PROJECT WM-11/TRV/83/03/10/0

SUBJECT: REPORT ON TRIP TO DENVER FOR WORKSHOP ON REVIEW OF  
HYDROGEOLOGIC TESTING DATA FOR THE NEVADA TEST SITE

Draft Trip Report  
NNWSI Hydrogeology Workshop  
January 18-20 and 27-28, 1983

Figure 2. U.S.G.S. conceptual model of water movement in the vadose zone.

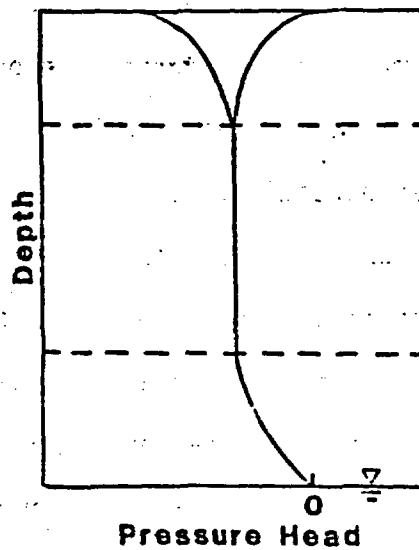
In our view, more measurement and more thought are needed before the above conceptual model is firmly established. One unknown mentioned by the NNWSI team is the interaction between fractures and matrix in the densely welded zone. The NRC team was also more generally concerned about whether soil-science concepts developed in near-surface studies would be applicable to deep unsaturated zones. One issue of particular concern to GeoTrans is the possibility that vapor-phase water movement is important. This would complicate interpretation of hydrogeologic phenomena in the unsaturated zone.
